Access Compliance Report

Public Rights-of-Way

(Curb Ramps)

Intersection ID: 52591	Main Street: INNOVATION_DR	Cross Street: NOBLES_AV	Location: NW
ADA ID: 394B57B42F3D	Ramp Type: Perp	Initial Pass/Fail: Fail	Overall Compliance: No
Severity Score: 12.5			
Codes/Mitigation Info/Possible Solution		Field Measurements/Component Compliance

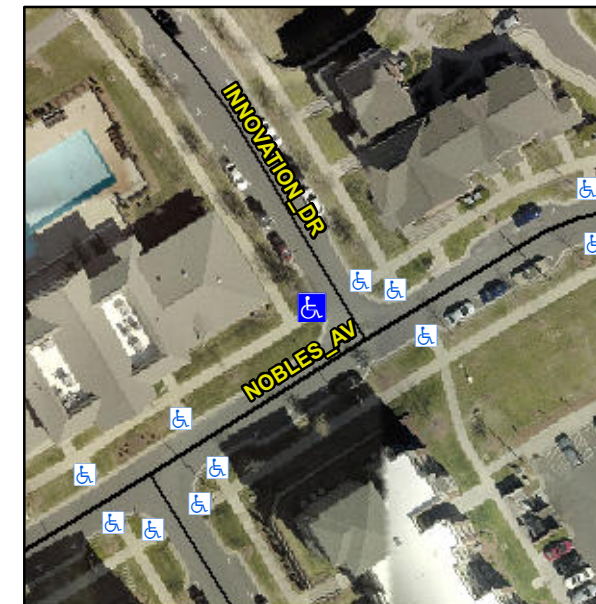
Not Found, R304.5.3

Compliance	Description	Data	Compliance	Description	Data
N/A	Ramp Length (in)	78.0	Yes	Ramp Slope (%)	5.5
Yes	Ramp Width (in)	72.0	No	Ramp XSlope (%)	5.5
N/A	Flare Type LT	N/A	N/A	Flare Type RT	N/A
N/A	Flare Slope LT (%)	N/A	N/A	Flare Slope RT (%)	N/A
N/A	Flare Traversable LT?	N/A	N/A	Flare Traversable RT?	N/A
N/A	Landing Length (in)	N/A	N/A	DWS Provided?	N/A
N/A	Landing Width (in)	N/A	N/A	DWS Contrast?	N/A
N/A	Landing Slope (%)	N/A	N/A	DWS Length (in)	N/A
N/A	Landing X Slope (%)	N/A	N/A	DWS Full Width?	N/A
N/A	Landing Curb? (Y/N)	N/A	N/A	DWS Offset (in)	N/A
N/A	Shared Landing?	N/A			
N/A	Gutter Ponding?	N/A	N/A	Gutter Slope (%)	N/A
N/A	Gutter Lip Ht (in)	N/A	N/A	Gutter X Slope (%)	N/A
N/A	Painted X Walk1?	No	N/A	Painted X Walk2?	N/A
	X Walk 1 Direction	To NE		X Walk 2 Direction	N/A
N/A	X Walk 1 Width (in)	N/A	N/A	X Walk 2 Width (in)	N/A
	X Walk 1 Slope (%)	4.5		X Walk 2 Slope (%)	N/A
	X Walk 1 X Slope (%)	0.2		X Walk 2 X Slope (%)	N/A

Remove & Replace Entire Ramp.
